BMP NUMBER: **PC033**

Upper wet pond located on the north side of the main entrance road; Combined folder with PC033

MASTER SITE PLAN
FOR THE CLUSTER DEVELOPMENT
LONGHILL GATE
LOCATED
JAMES CITY COUNTY, VIRGINIA
SCALE : 1" = 50' DATE: JAN. 14, 1986
OWNER / DEVELOPER
LONGHILL GATE ASSOCIATES

PRIDE – Demonstration No. 9
Pond Buffer at Longhill Gate

Photo 8 – Tower Hill
Note voids in the bottom of the sidewalk, which demonstrate poor construction workmanship.

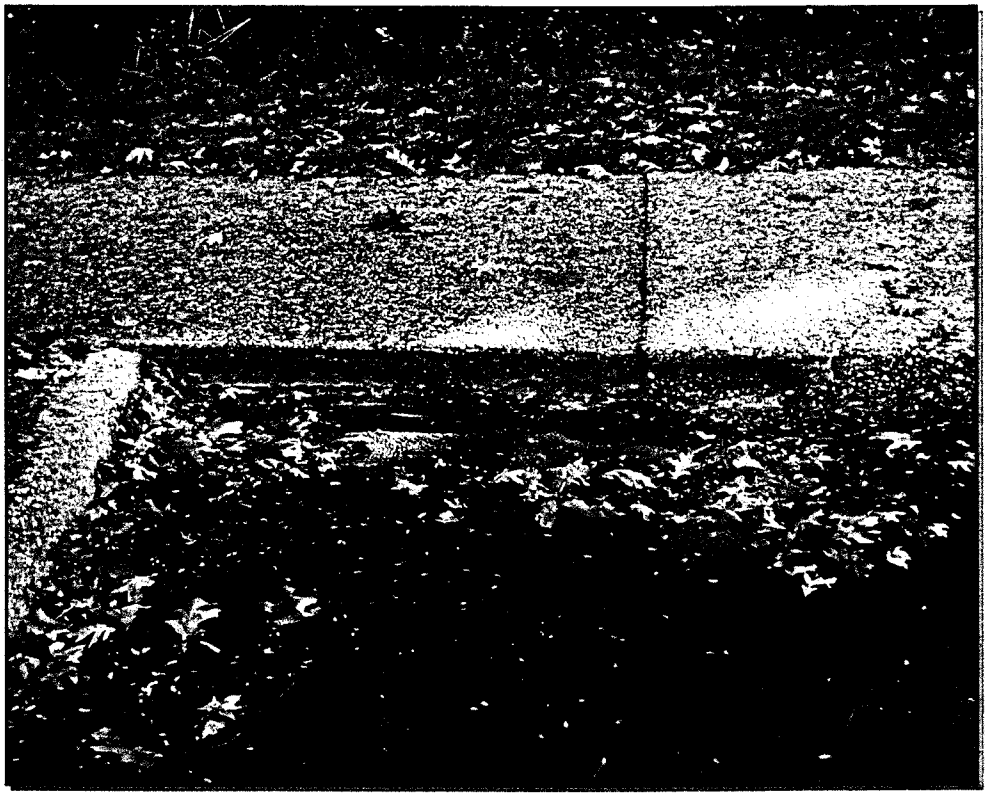
With respect to the sidewalks, AES recommends that all cracked and broken sidewalks, and areas of the sidewalk where poor workmanship is observable, continue to be replaced to minimize pedestrian hazards. During replacement, the soils under the sidewalk should be compacted and the replacement sidewalk should be installed using fiber reinforced concrete, 4-inches thick.

Photo 10 – Highgate Green
Note the cracks in the paved ditch section; there is also evidence of large voids beneath the paved channel in several locations.

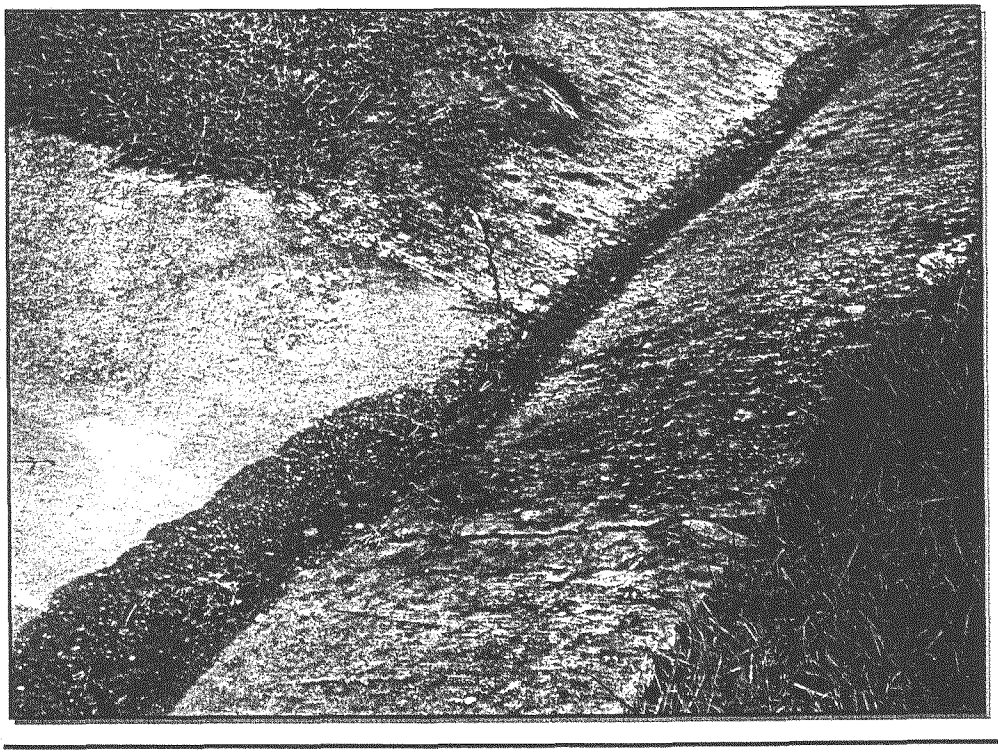
pumped into the void regions. All paved ditches, which have become broken and misaligned due to lack of proper support must be repaired or replaced. AES suggests the damaged section of the ditch be removed between the crack control joints, the voids in the earth filled with compacted fill material, and a replacement paved ditch be constructed using fiber reinforced concrete.

Photo 14 – Longhill Gate Entrance Road Causeway
Obstruction of cross-culvert preventing free-flow of stormwater to other pond.

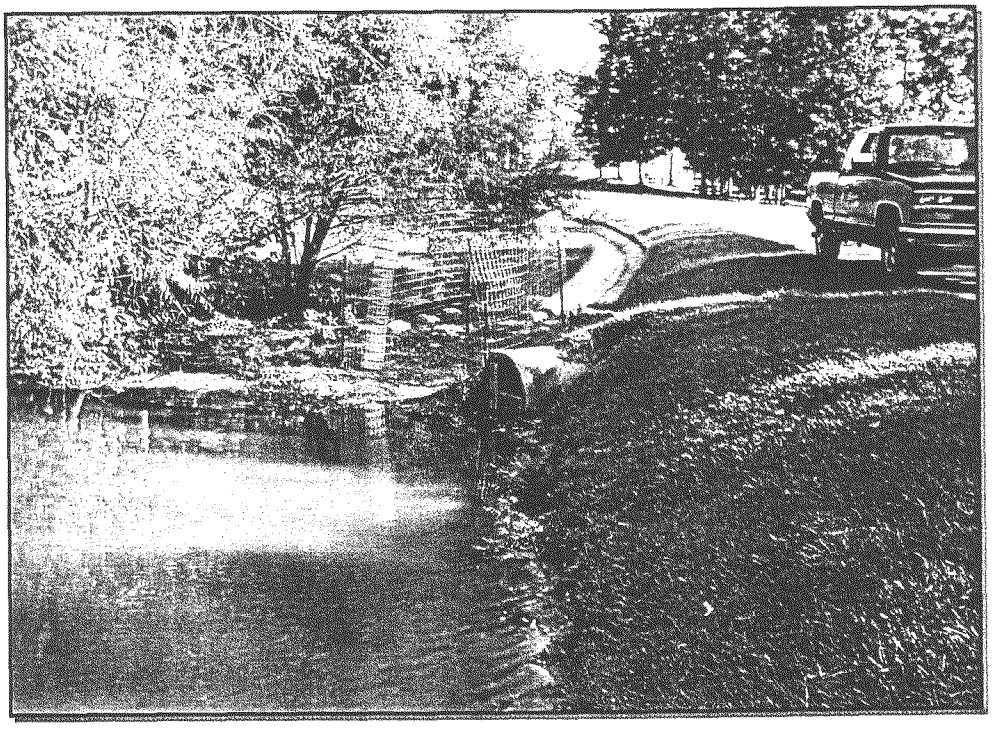
Just to the left of *Longhill Gate* (entrance road), a small pond is found. Dewatered by a culvert under *Longhill Gate*, an obstruction to the inlet of the culvert pipe was noted (See Photo 14). As this obstruction prevents the culvert functioning efficiently, AES recommends that this item be removed.

Photo 19 – Tower Hill
Maintenance potential and pedestrian hazard. A smooth transition should be provided to the concrete ditch section.

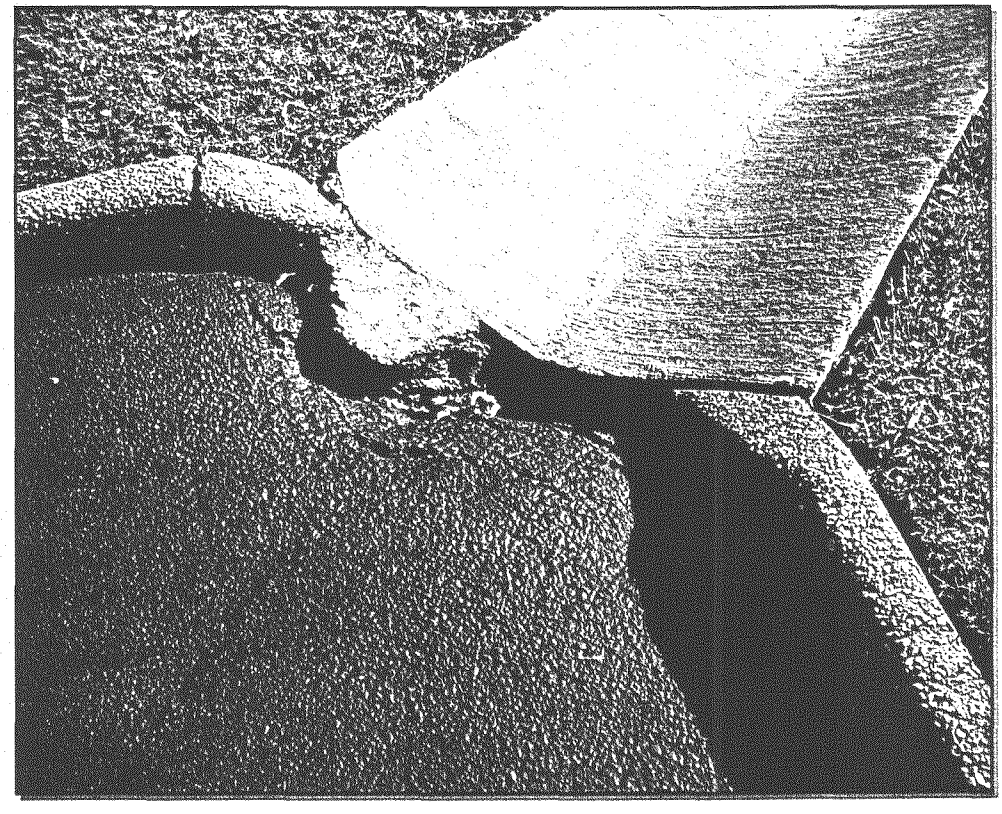
A pedestrian hazard was noted in the Tower Hill section (see Photo 19), this should be alleviated by a smooth transition of asphalt to the concrete swale. This will prevent the undermining of the drainage way as well.

Photo 21 – Recreation Area
Standing water between the tennis courts and pool. Swa should be regraded to provic positive drainage and seedec

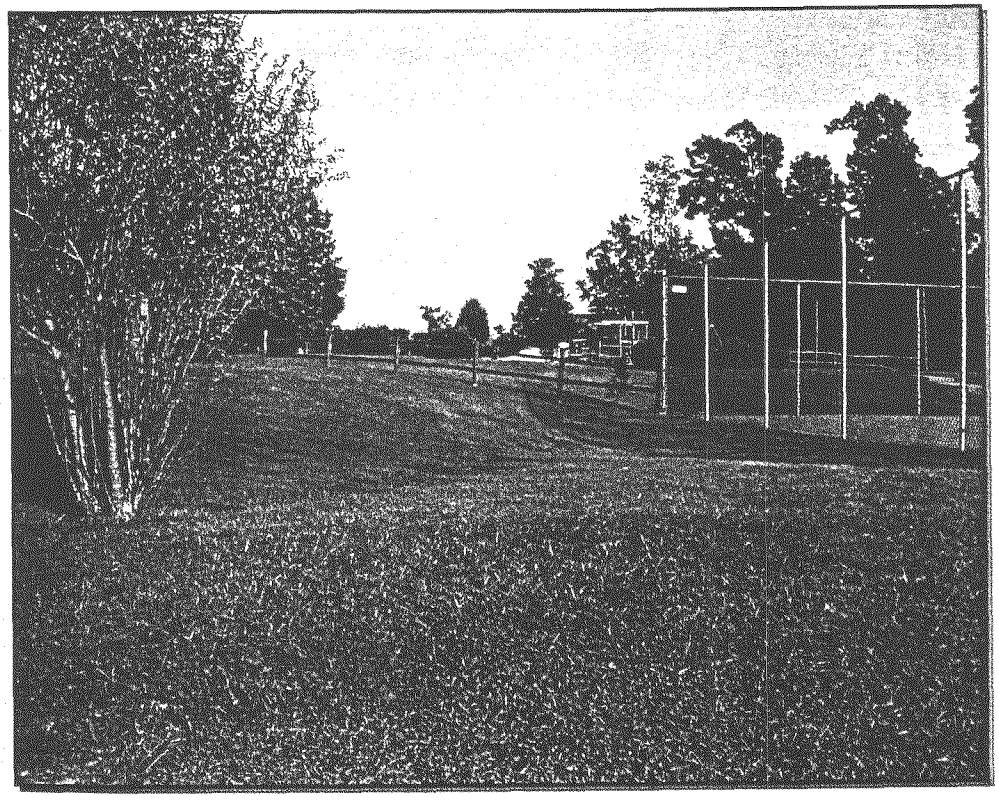
When inspecting the recreation area, an area between the tennis courts and the pool was evidenced to be poorly graded, with standing water. (See Photo 21) This area should be regraded to provide positive drainage towards the pond. After grading and shaping the area should be seeded and a mature stand of grass maintained.

Photo 22 – Recreation Area
Evidence of standing water behind the pool. Area should be regraded to provide positive drainage and seeded.

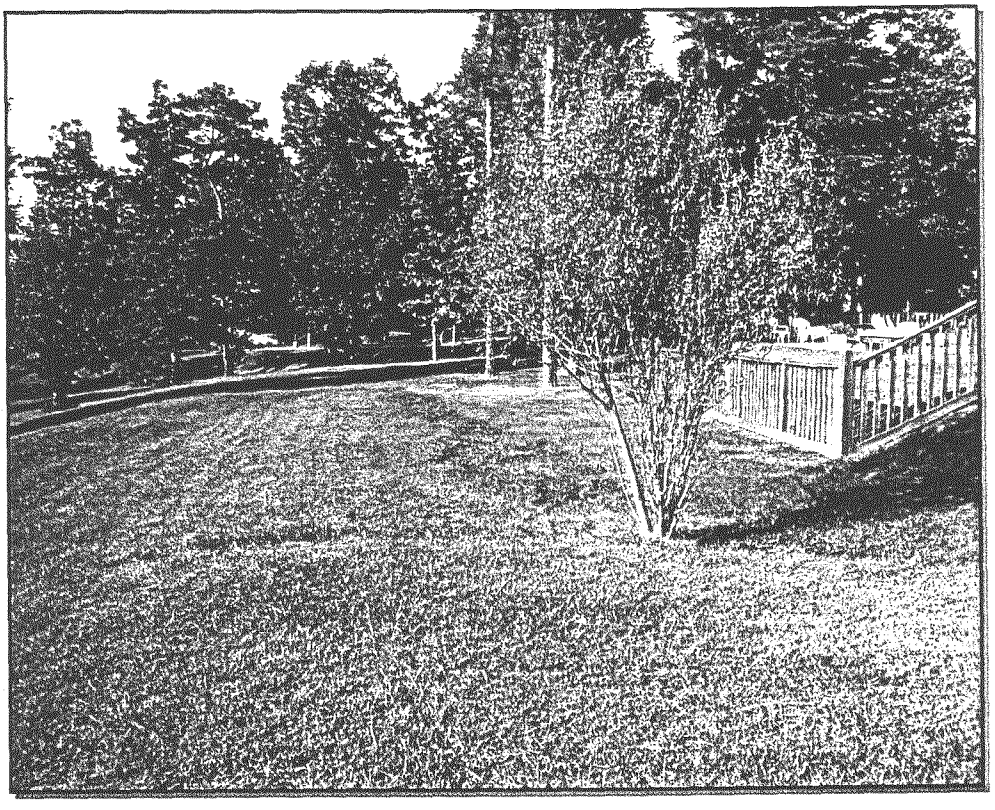
Another area of concern is located nearby between the pool and the pond. (See Photo 22) This area should also be repaired in a similar manner as the above-mentioned area.
